**Denison Mines Corp.
Wheeler River Uranium Project
Draft Environmental Impact Statement**

Technical Review

**Submitted by:
Birch Narrows Dene Nation**

Figure 6: Modelled selenium migration from the ore body post-decommissioning (Ecometrix, 2022)

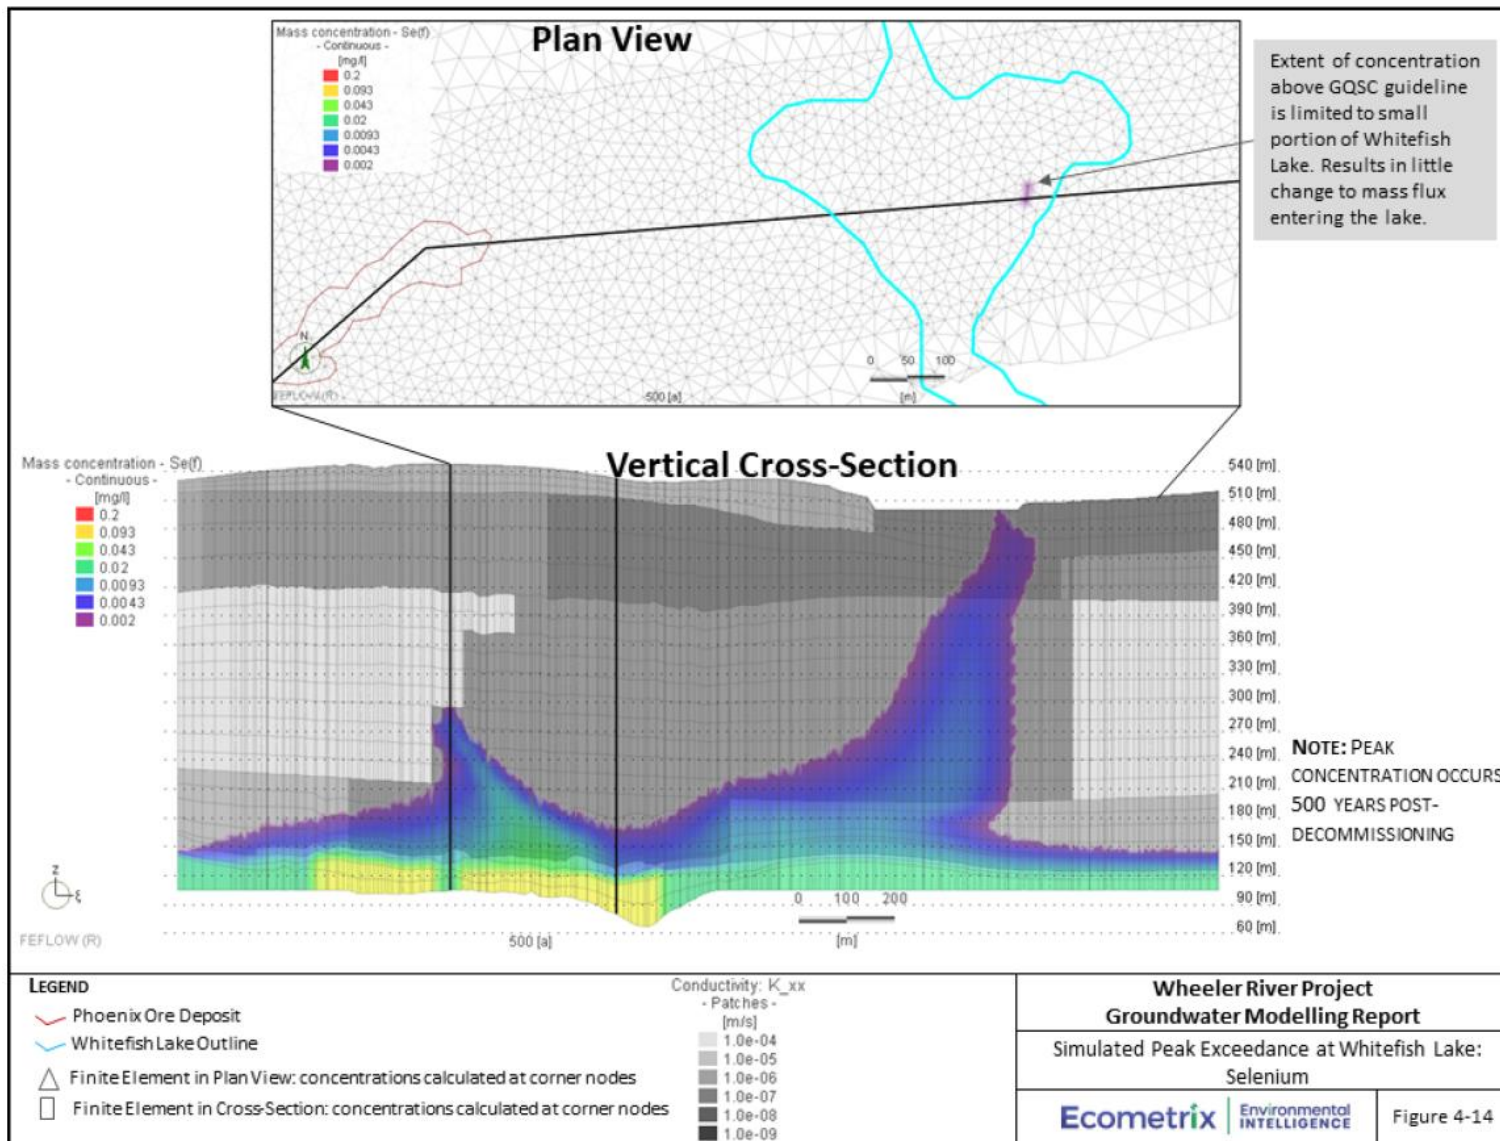
After the mine is decommissioned, the freeze wall around the mining area will thaw and groundwater from the ore body (which will have high concentrations of many metals) will interact naturally with the surrounding natural groundwater. To understand how the groundwater impacted by mining will migrate and evolve over time, Denison has undertaken a detailed analysis of how groundwater will flow (using software called FEFLOW) and how the chemistry of the groundwater will change over time (using a software called PHREEQC). Denison ran several different models to predict how groundwater chemistry will flow and evolve over time. Based on their modelling, they expect mine-contaminated groundwater to flow towards Whitefish Lake. Denison's model indicates that selenium and cobalt will be the only contaminants that reach Whitefish Lake in concentrations above water quality guidelines. They expect the peak contamination of selenium to occur 500 years post-decommissioning of the mine, and peak cobalt contamination to occur 30,000 years post-decommissioning of the mine. Based on their model, they expect the changes to Whitefish Lake from the groundwater migration to be essentially undetectable in Whitefish Lake.
